**Coal Combustion Residue Impoundment
Round 9 - Dam Assessment Report**

Cliffside Steam Station

Ash Basin Dikes

Duke Energy Corporation
Mooreboro, North Carolina

PLAN OF UNITS 1-4 OLD DIKE
CLIFFSIDE UNITS 1-4 OLD ASH STORAGE BASIN
CLEVELAND COUNTY, NORTH CAROLINA

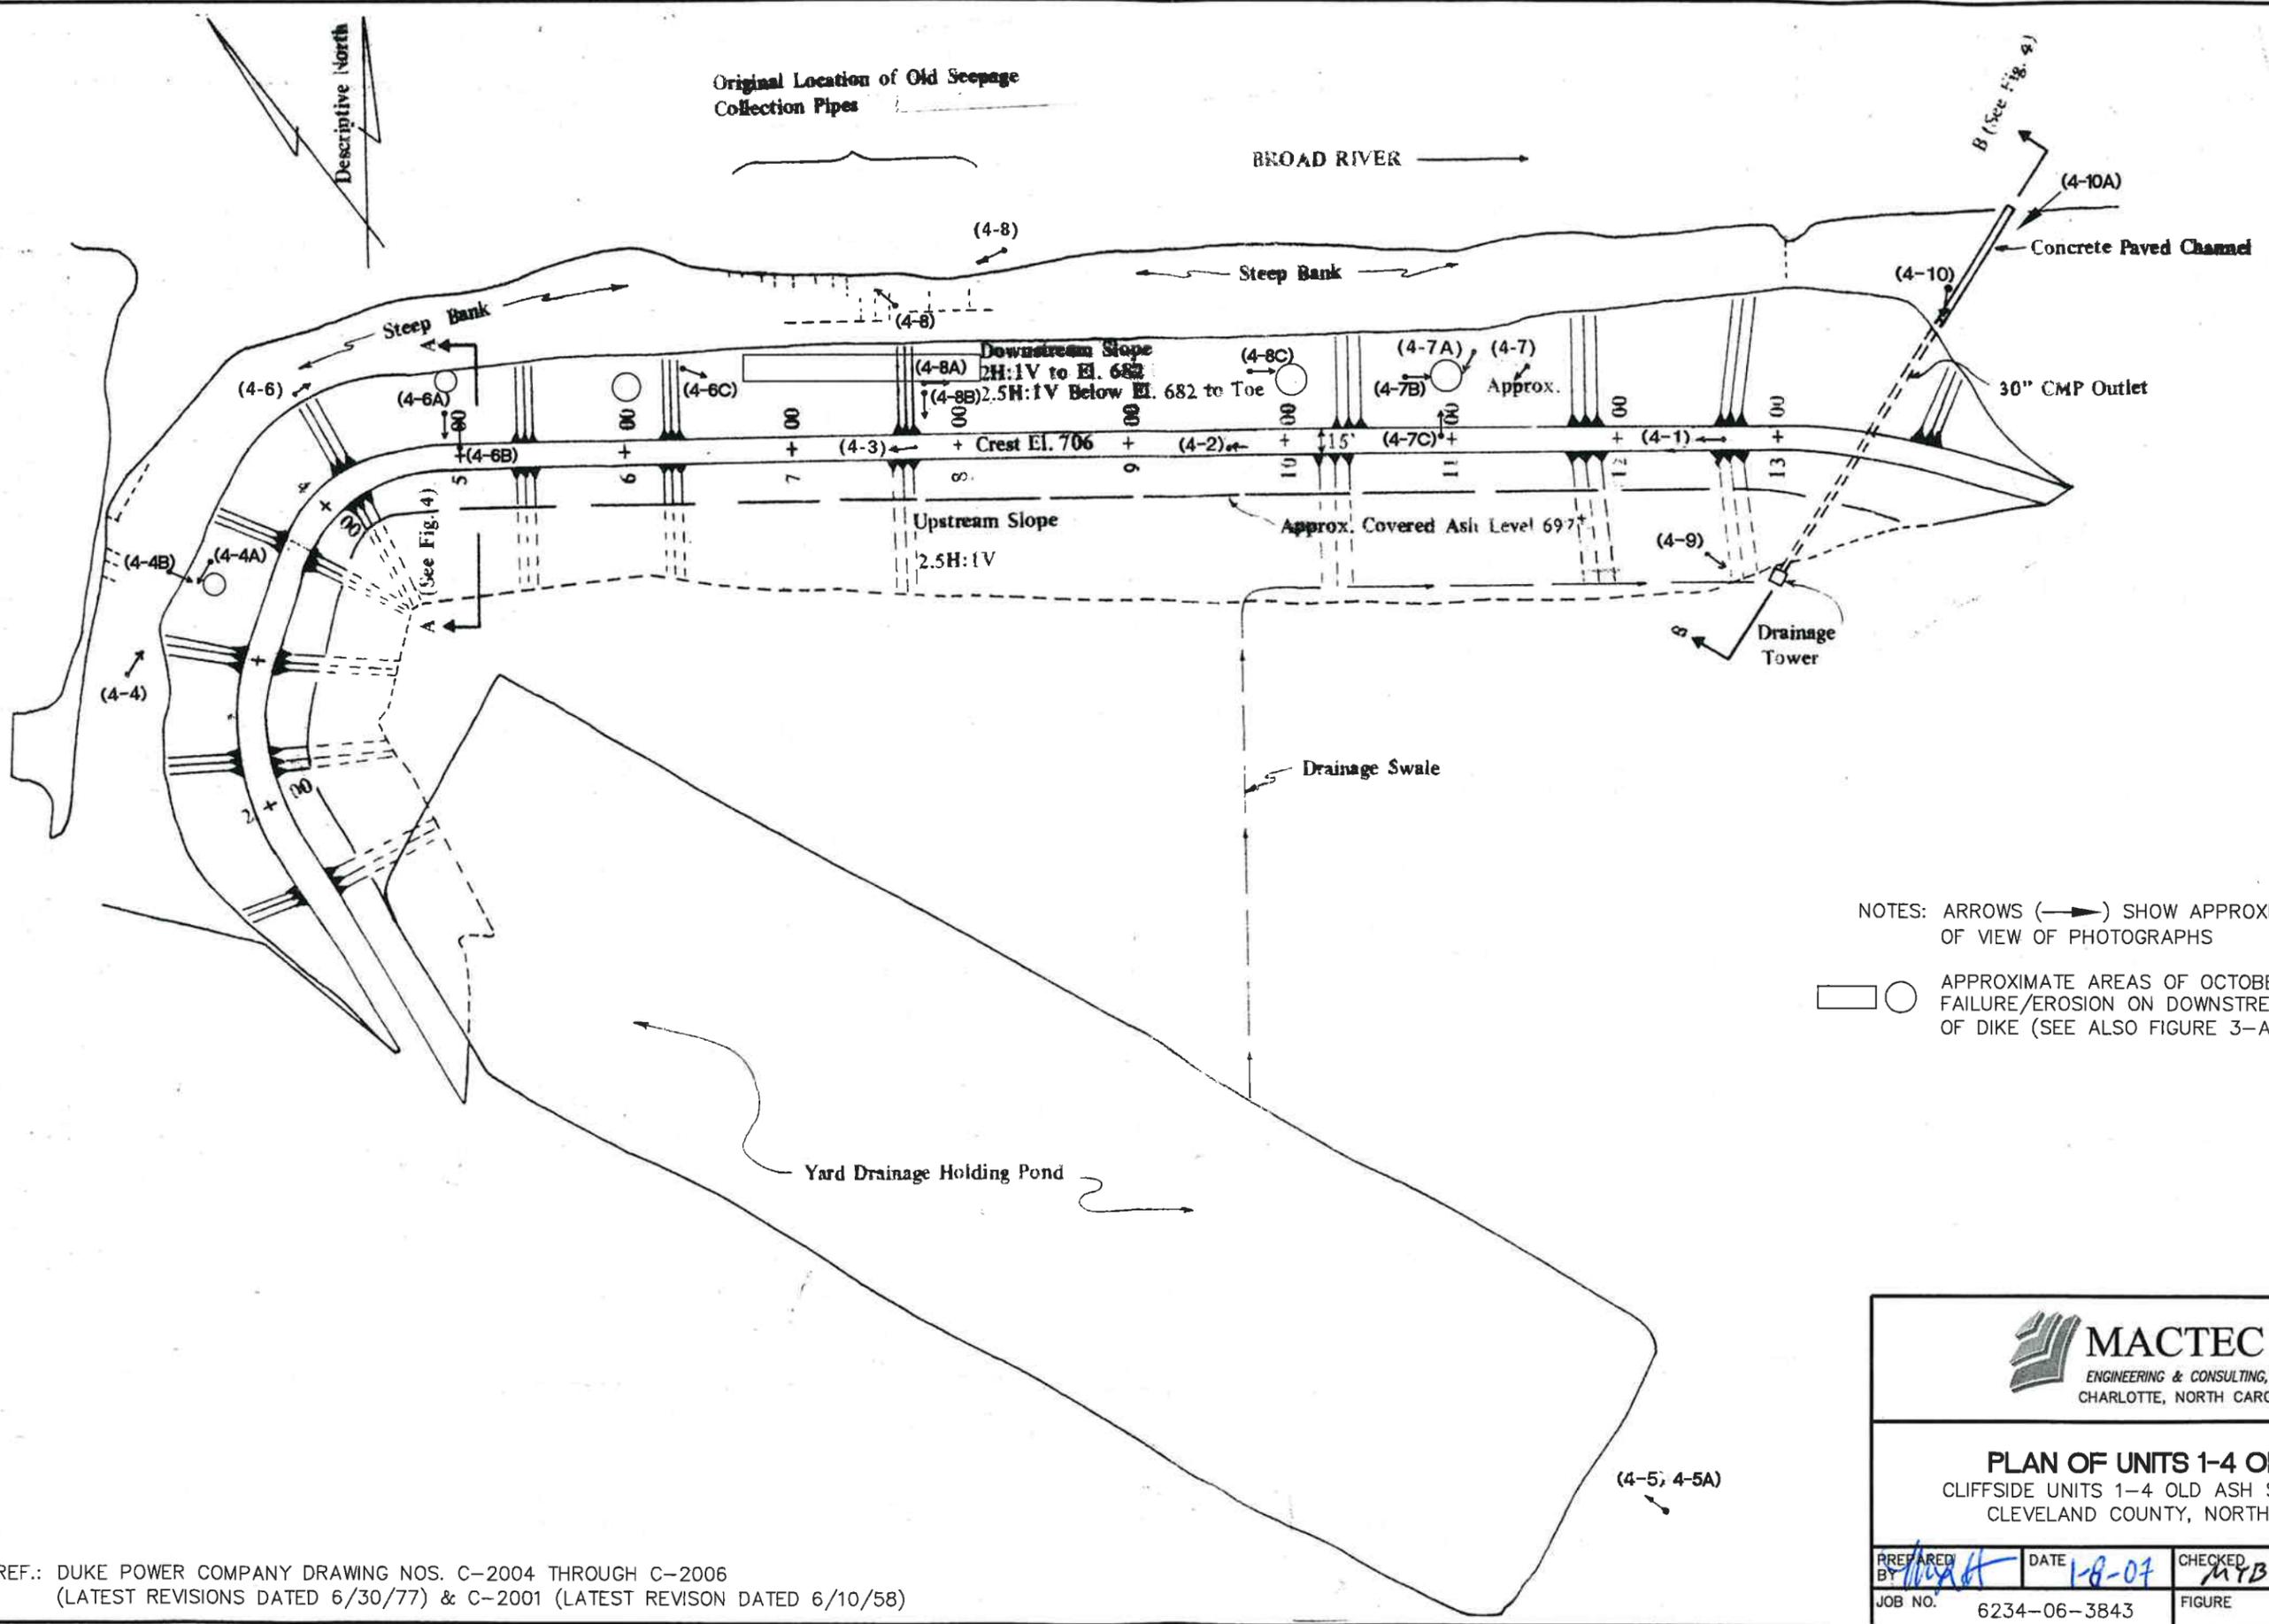
In October, 2005, a severe, previously discussed rainfall event occurred at the site. This event caused overflow in the Suck Creek Diversion canal located along the northwest side of the Units 1-4 ash basin dike, leading to overtopping of the dike at depressed locations of the crest and severe erosion of the lower portion of the downstream slope at several locations. Duke engaged Facilities Planning and Siting, Inc. of Charlotte (FPS) to produce repair drawings and to subcontract a grading contractor to oversee and perform the repairs. The damage locations are shown on Figures 3 and 3A. MACTEC was hired by FPS to provide engineering assistance regarding repair methodology and to provide soil technician services to observe the repair work and perform soil compaction testing during placement of structural fill. Repair plans call for restoring the failed and eroded areas to the previous slope contours and raising the crest of the Units 1-4 dike by about 1 ft.

○ APPROXIMATE AREAS OF OCTOBER, 2005 FAILURE/EROSION ON DOWNSTREAM SLOPE OF DIKE (SEE ALSO FIGURE 3-A)

10. Repair of the Units 1-4 retired ash basin will include not only the downstream slopes, but also placement of about 1 ft of new fill on the crest of the dike to create a level surface. This will remove the previous undulating area of the crest noted in this report. We recommend that the new dike crest be monitored for any reoccurrence of irregular surface settlement. If such settlement is detected, further investigation (see below) and/or remedial action will be necessary.

PIEZOMETERS AND OBSERVATION WELLS
 CLIFFSIDE STEAM STATION
 SUCK CREEK DOWNSTREAM
 ASH DIKE

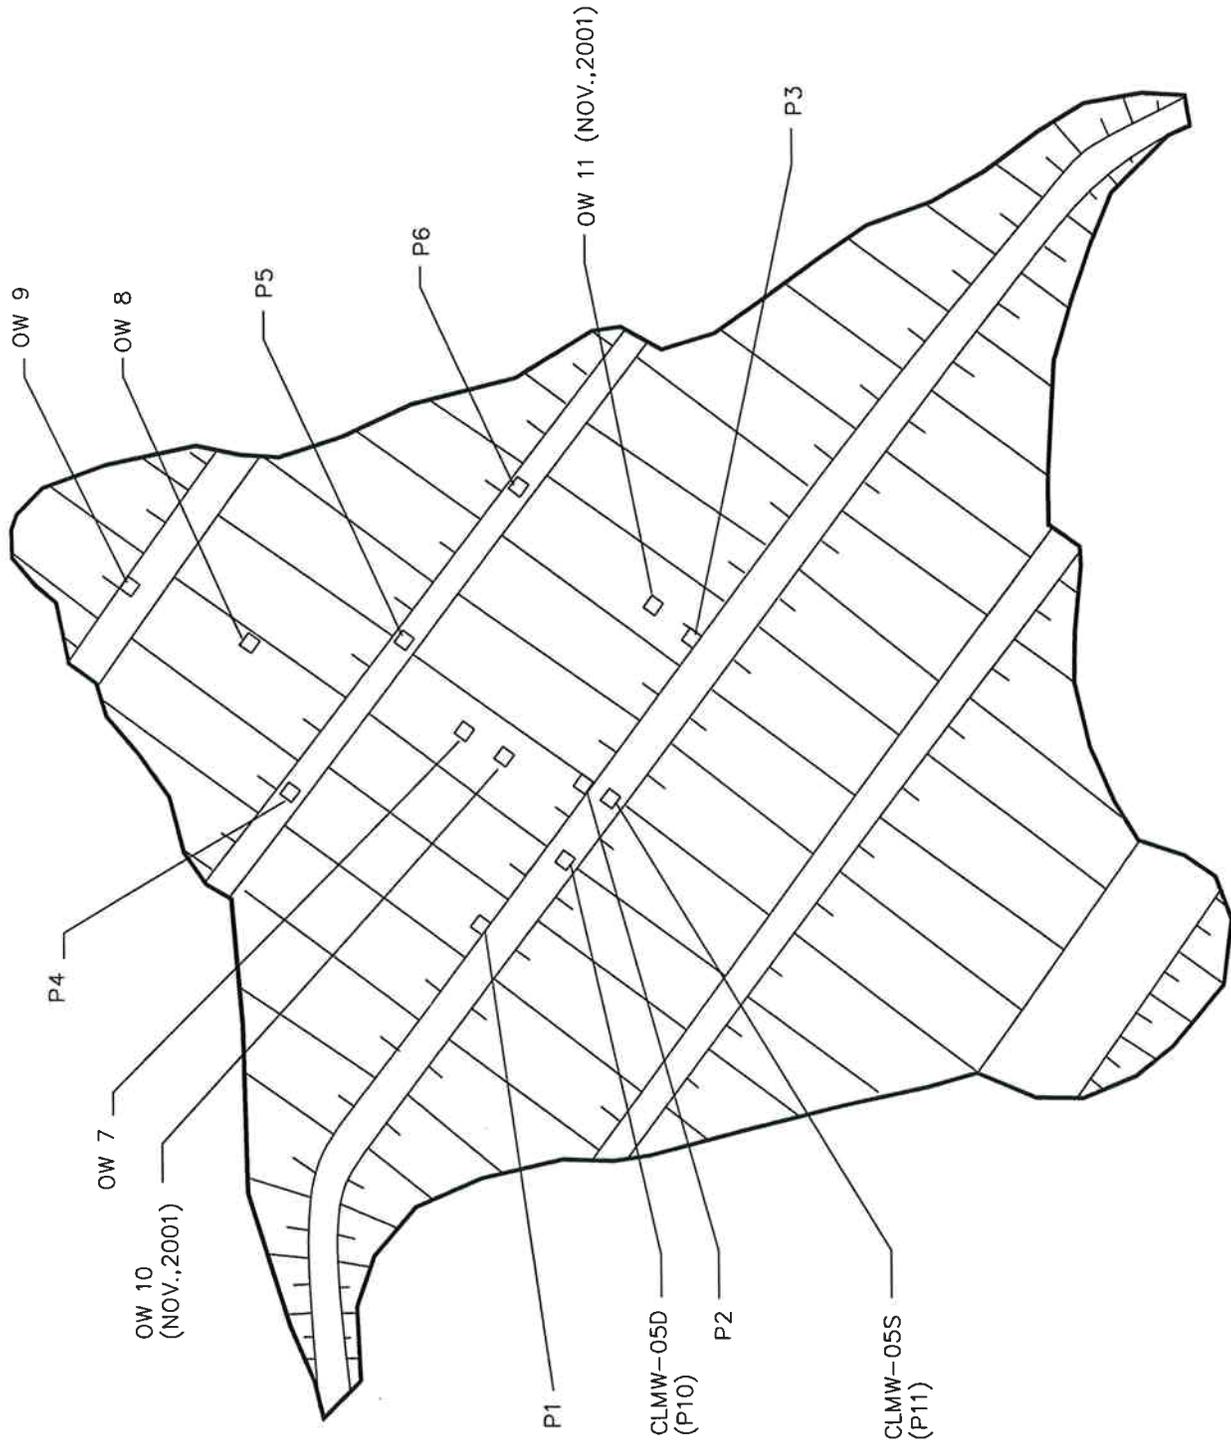
Approximate locations of all the above are shown on Figure C-1 in Appendix C. The individual readings of the piezometers and of the water levels in the Suck Creek ash basin are plotted in Appendix C. The pond level between the years 1989 and 1999 fluctuated between elevation 755 and about 758 ft-MSL. Beginning in early 2000, the pond was raised and fluctuated between 762 and about 762.5 (full pond is to be 772 ft) up to late 2004. The pond level dropped briefly to about 758.5 ft during the first quarter of 2005, then was raised to about elevation 764 through the remainder of 2005. The brief high pond level of the Suck Creek ash basin associated with the October 2005 storm event is not captured in the pond level data. (Pond level readings bracketing the October 2005 storm event were taken on September 28, 2005, October 27, 2005 and November 30, 2005. These three readings only varied from 763.5 to 763.7 ft). Beginning in early 2006, the
